**ADDENDUM
NO. 2**

November 3, 2022

**LIBERTY ELEMENTARY SCHOOL RENOVATIONS
Chesterton, IN 46304**

This Addendum consists of Pages ADD 2-1 through ADD 2-3 and attached Addendum No. 2 from Gibraltar Design dated November 2, 2022 and consisting of 7 pages, Specification Section 08 33 00 - Rolling Doors and Grilles, and 41 Drawings.

© GIBRALTAR DESIGN SHEET
A-101

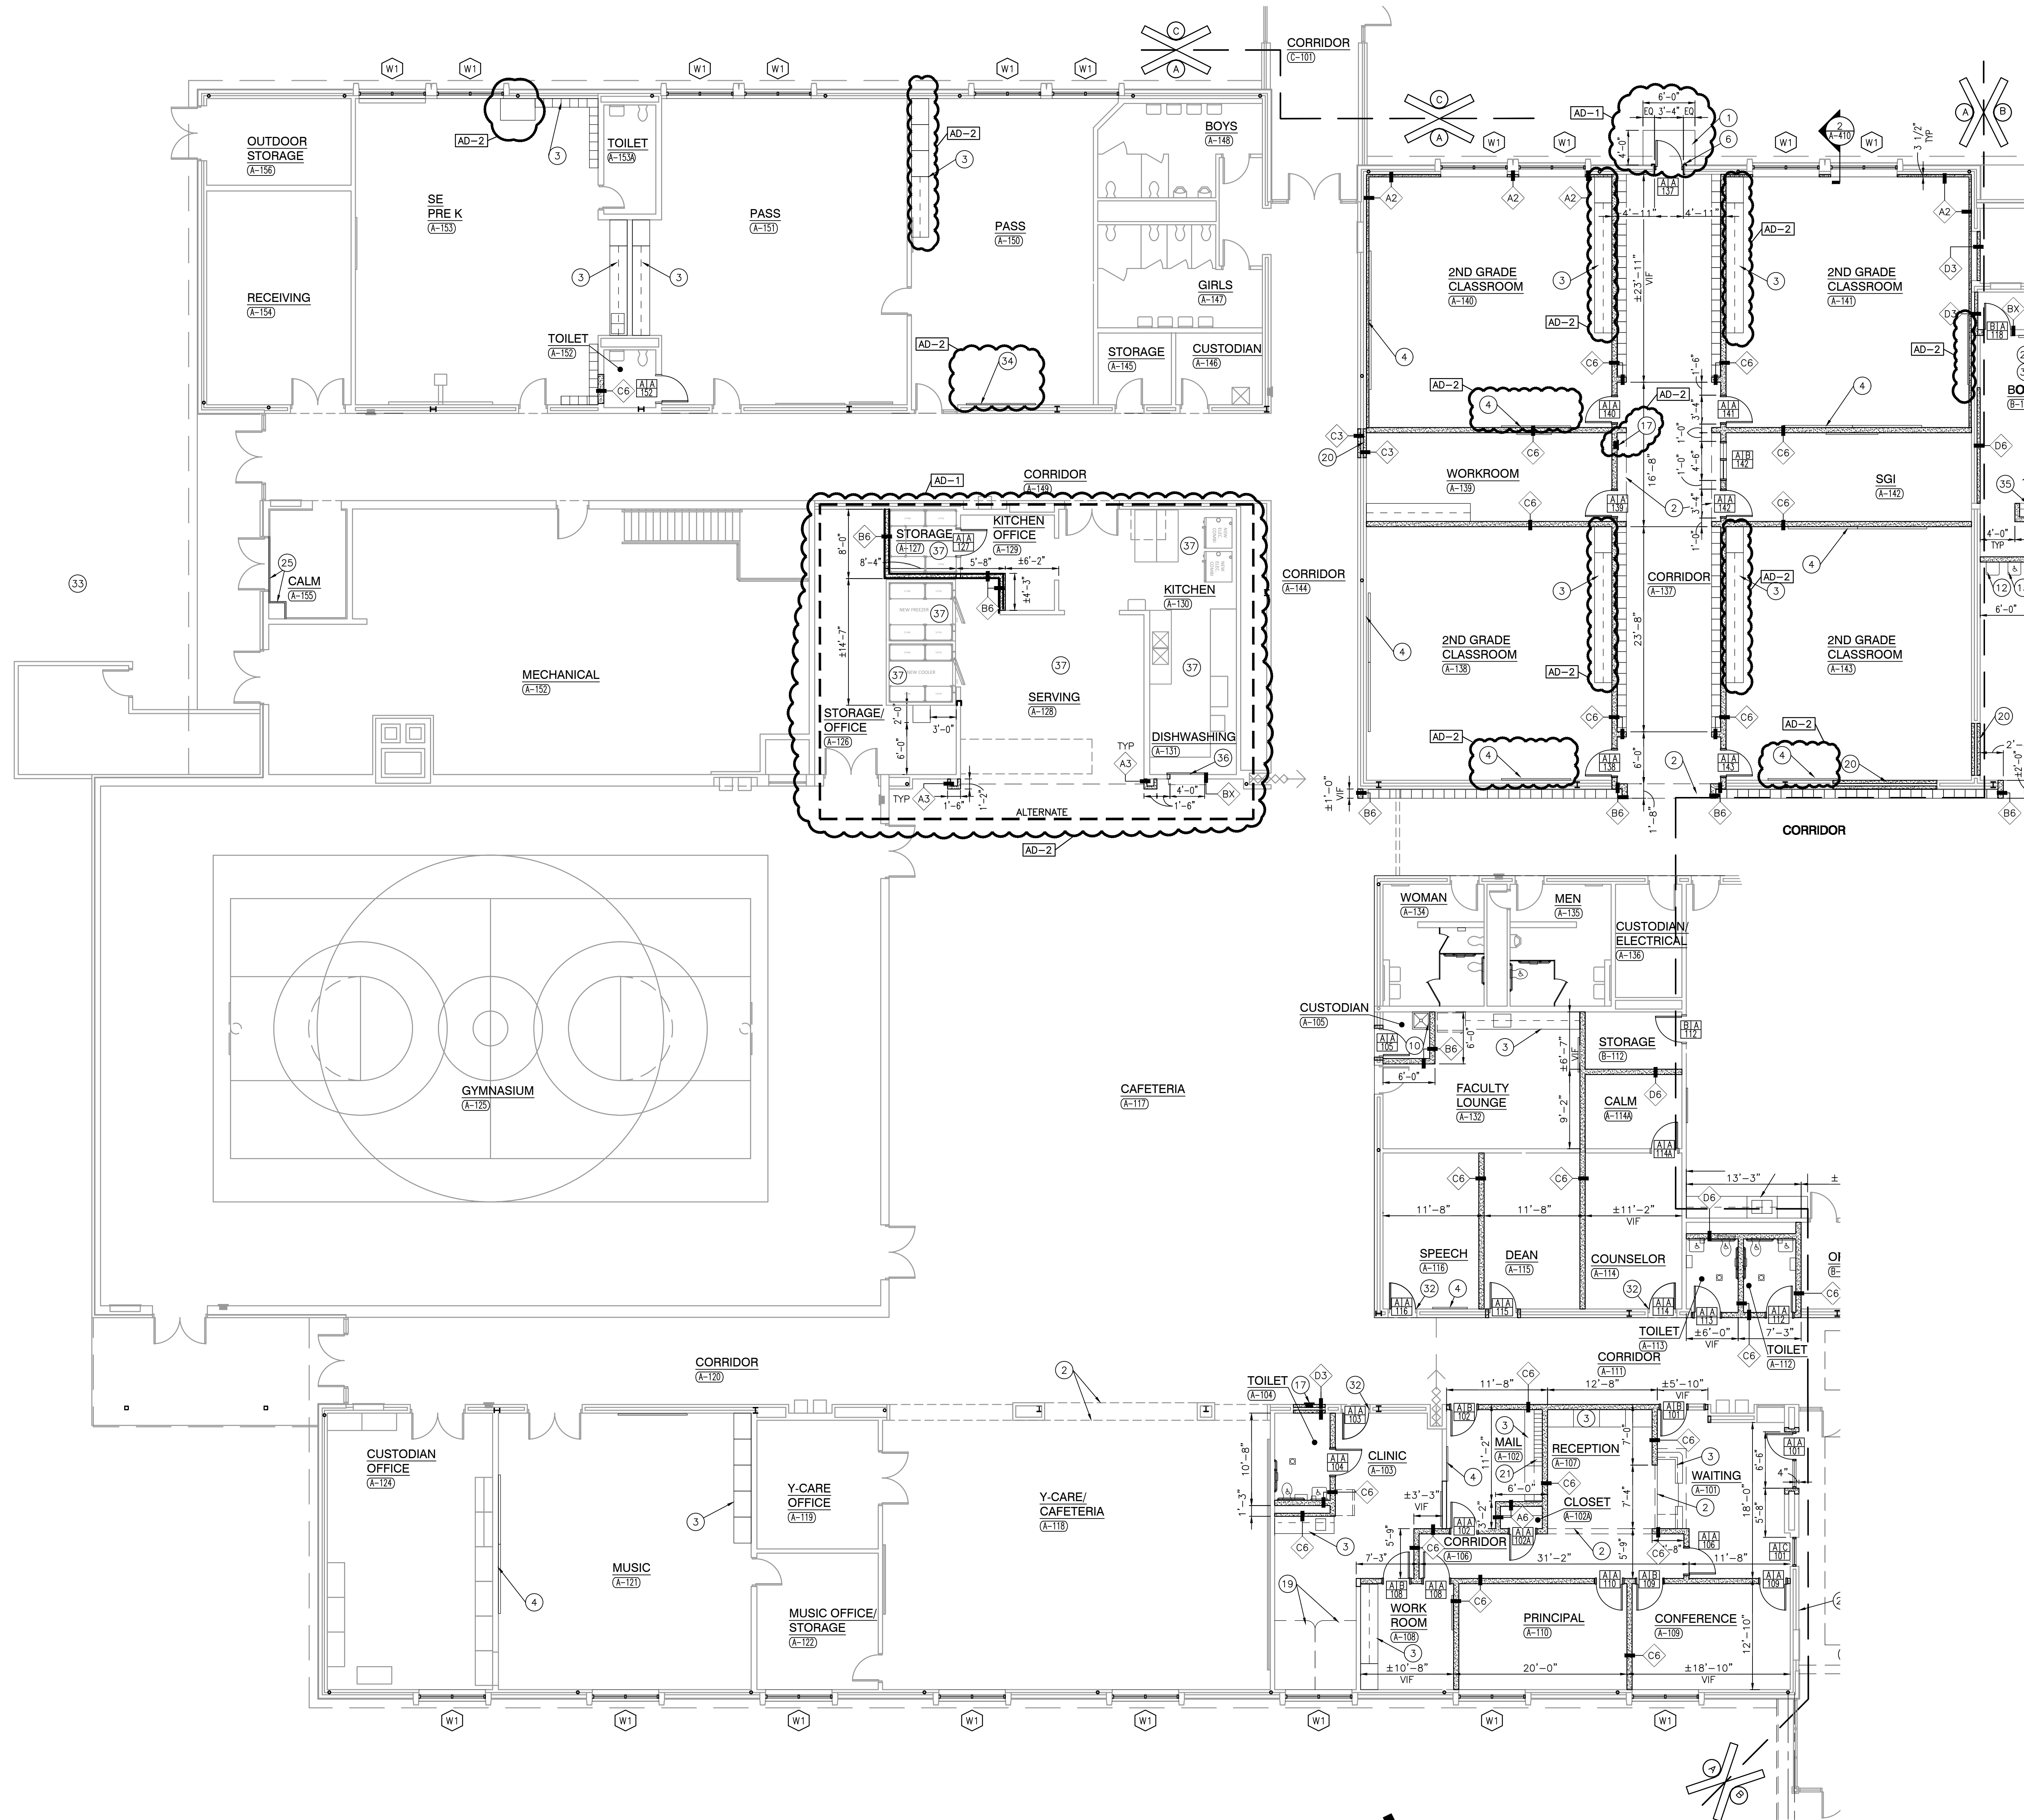
11. Sheet A-101

- A. Refer to revised full size drawings, included in this Addendum, for the following revisions:
1. Add Plan Notes 36 and 37
 2. Update casework and markerboards throughout to coordinate with Equipment plans.
 3. Add new pilasters to Serving A-128 and coiling counter door to Dishwashing A-131.
 4. Relocate fire extinguisher cabinet in Corridor A-137.

A-102

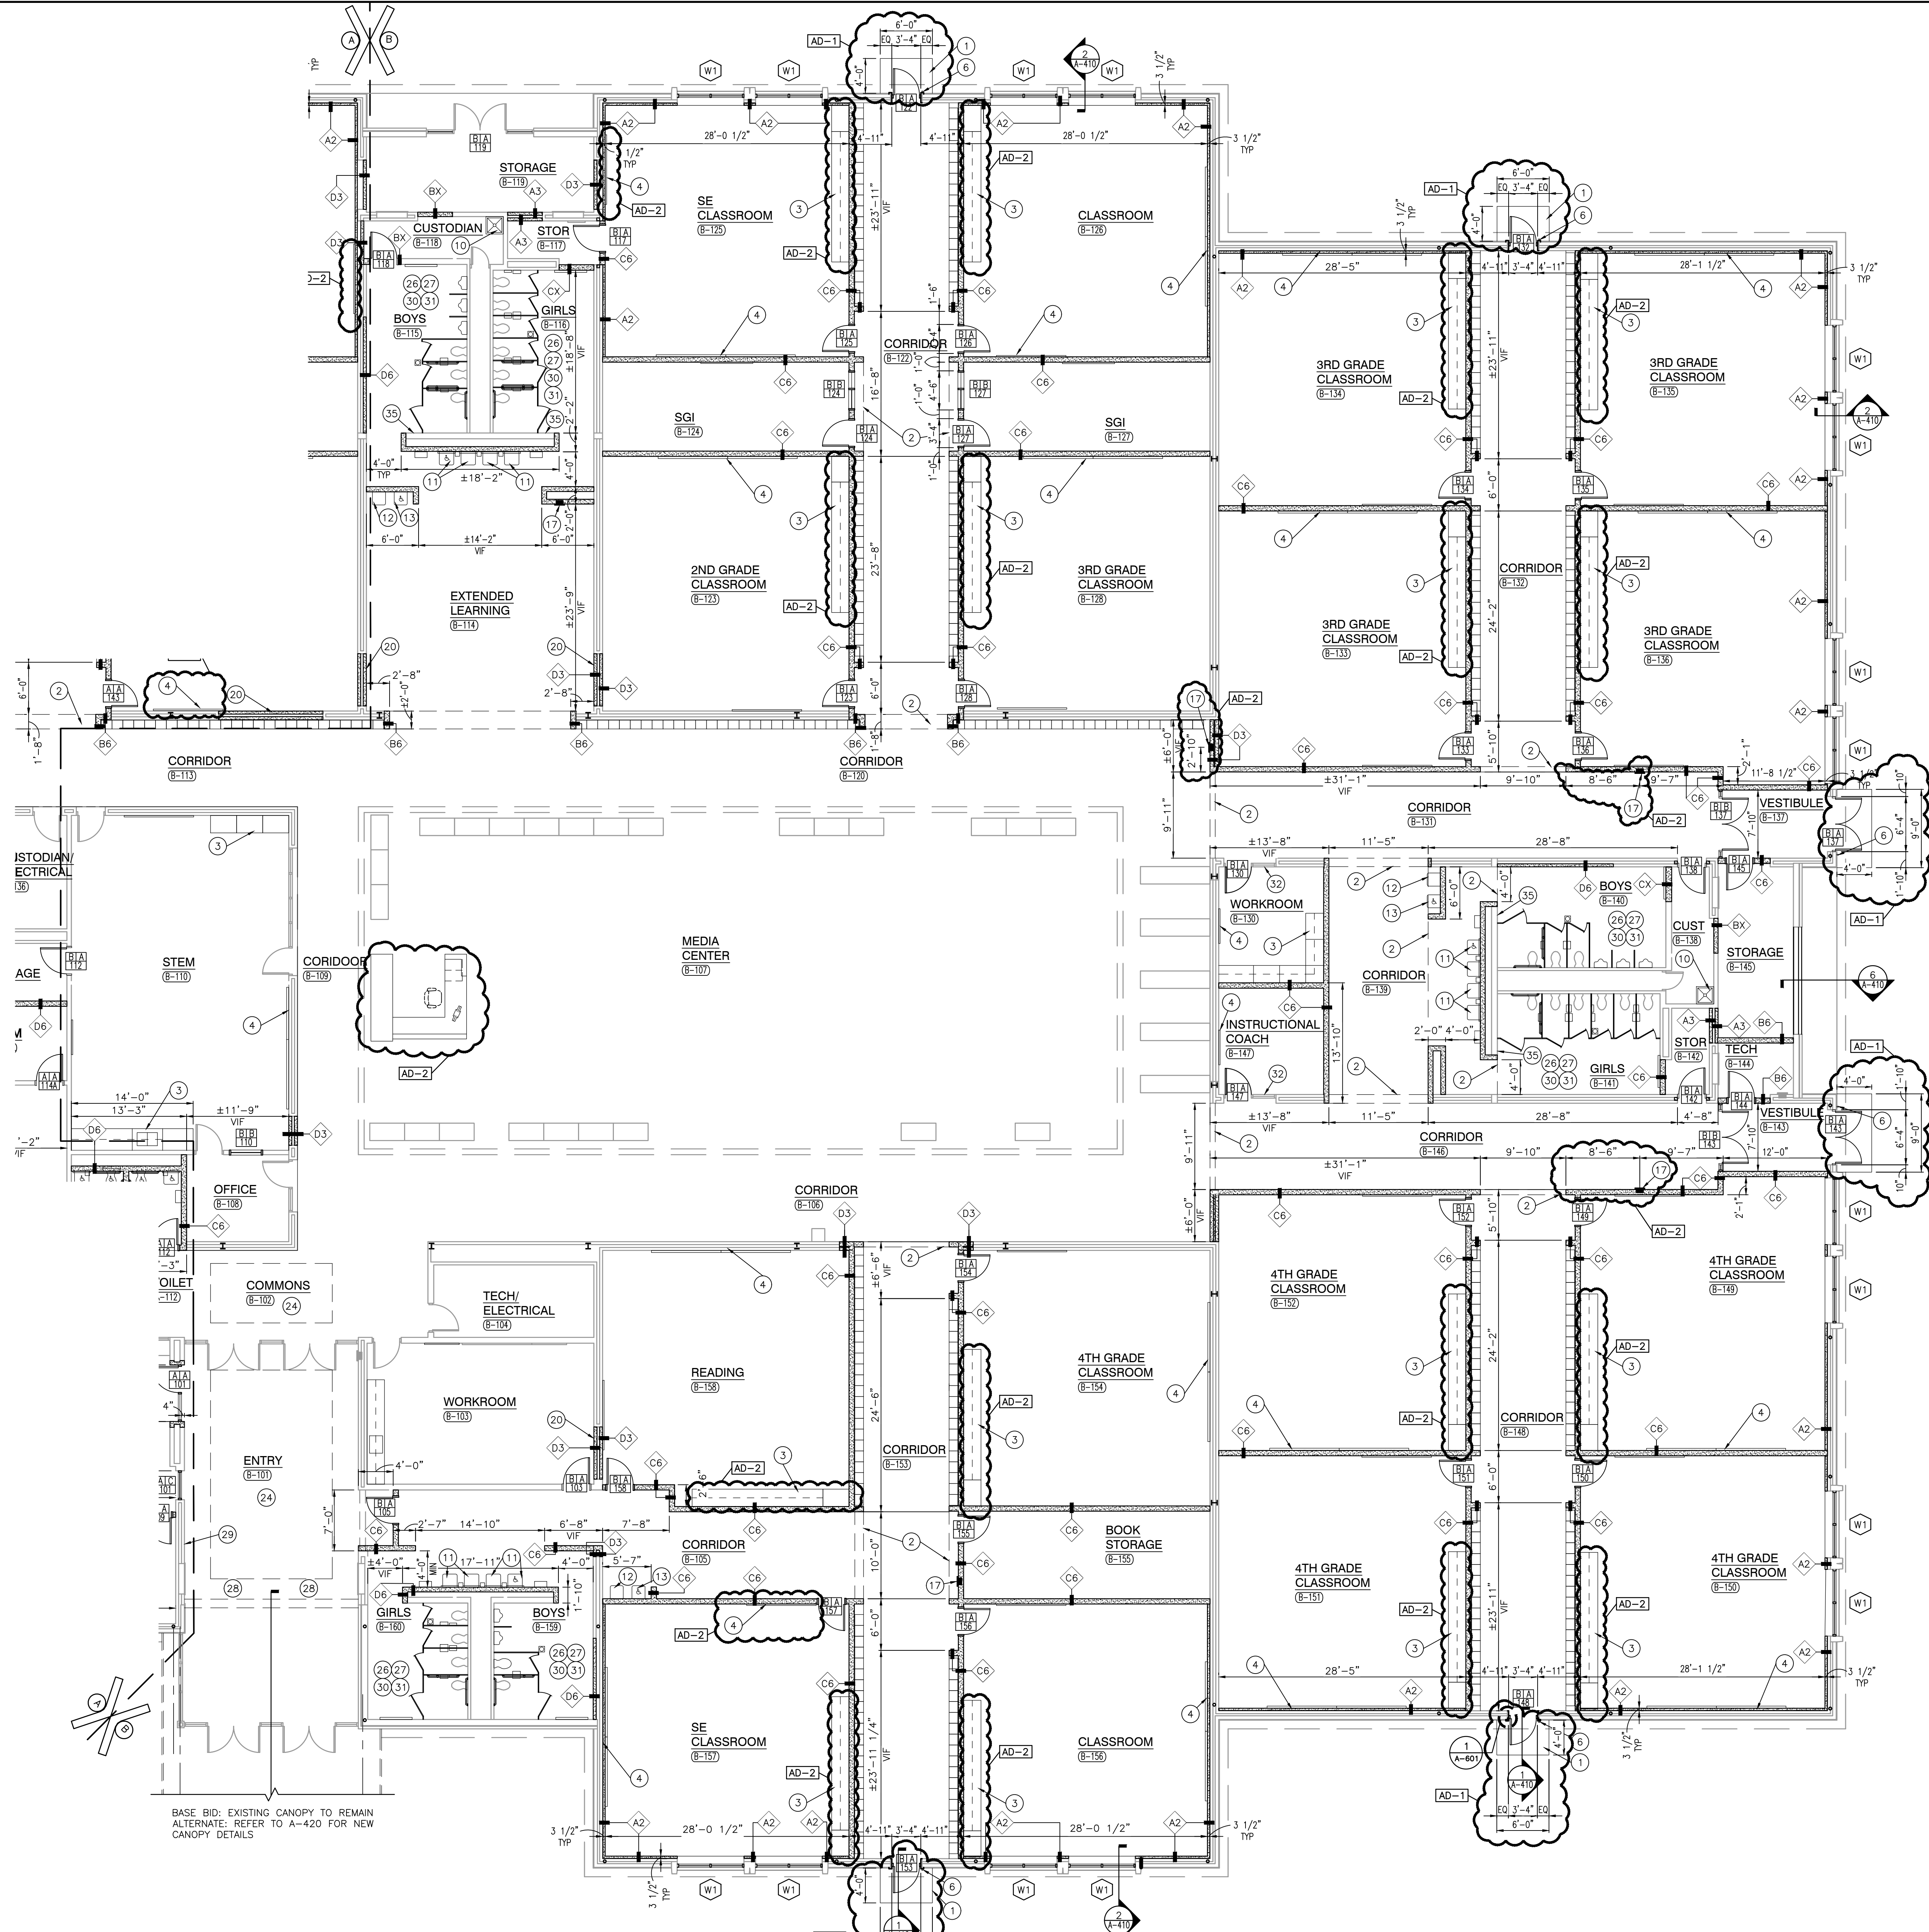
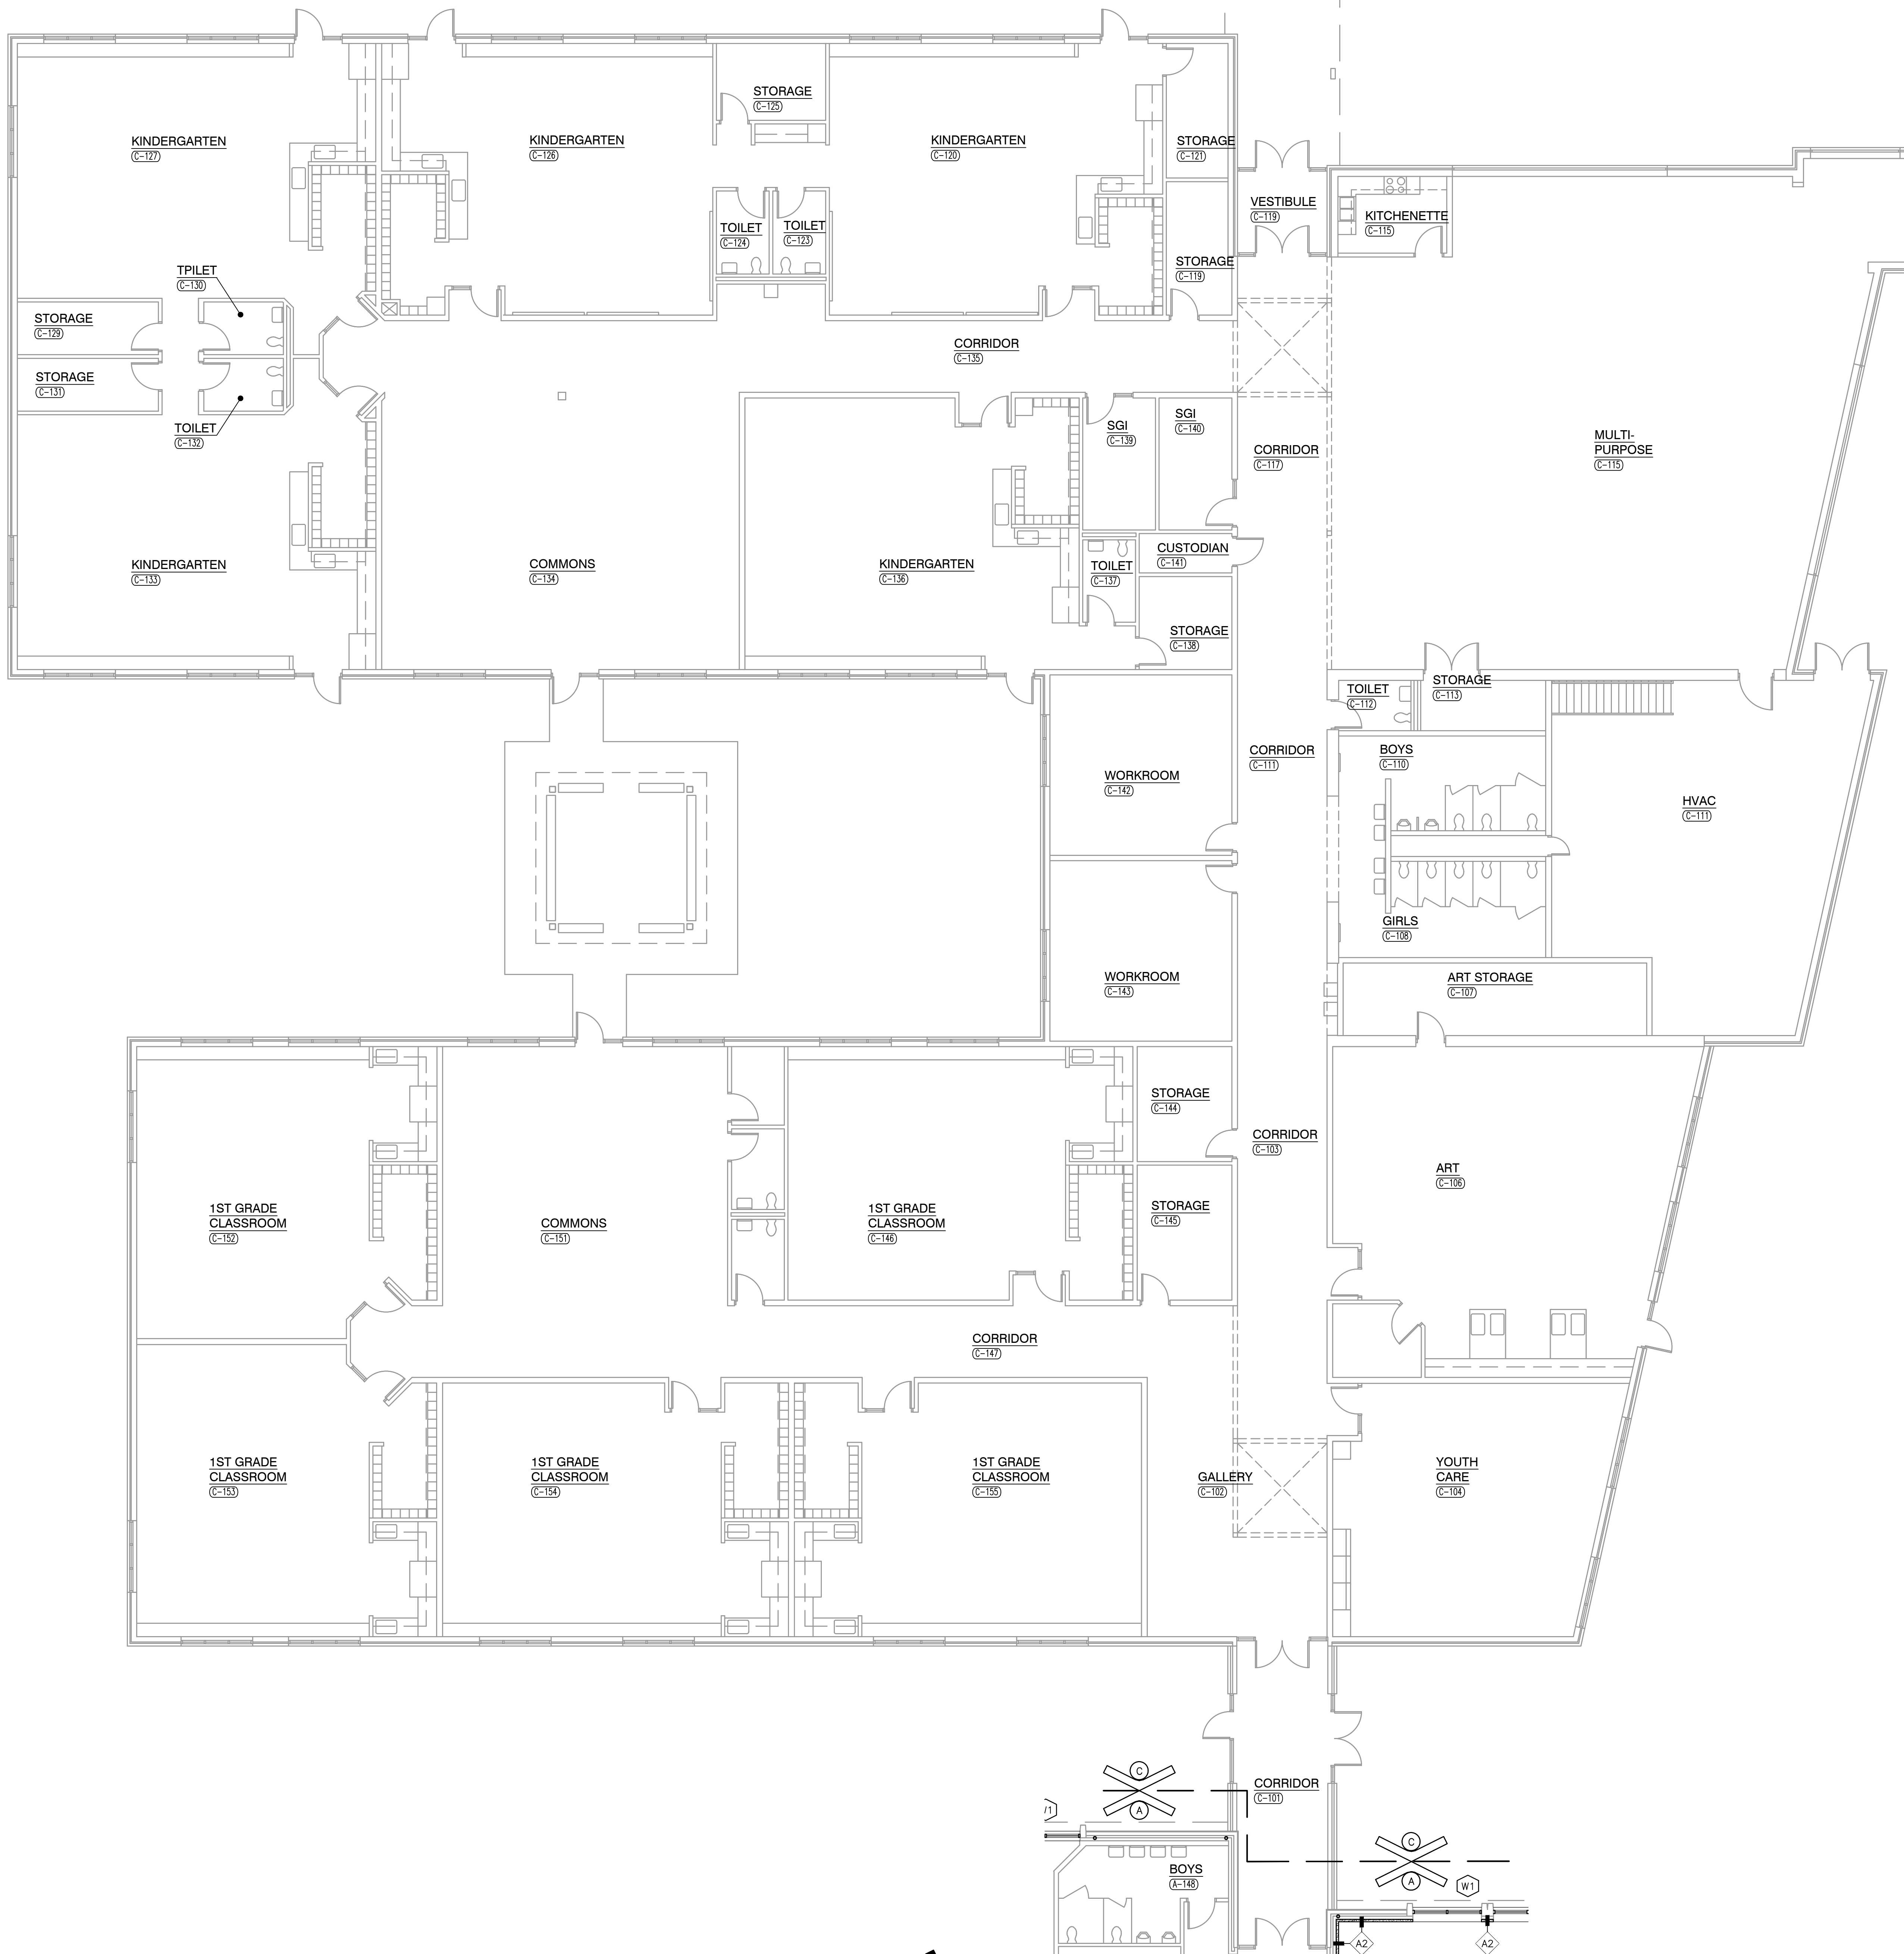
12. Sheet A-102

- A. Refer to revised full size drawings, included in this Addendum, for the following revisions:
1. Add Plan Notes 36 and 37
 2. Update casework and markerboards throughout to coordinate with Equipment plans.
 3. Add new circulation desk to Media Center B-107.
 4. Relocate fire extinguisher cabinets in Corridor B-120, Corridor B-131, and Corridor B-146.
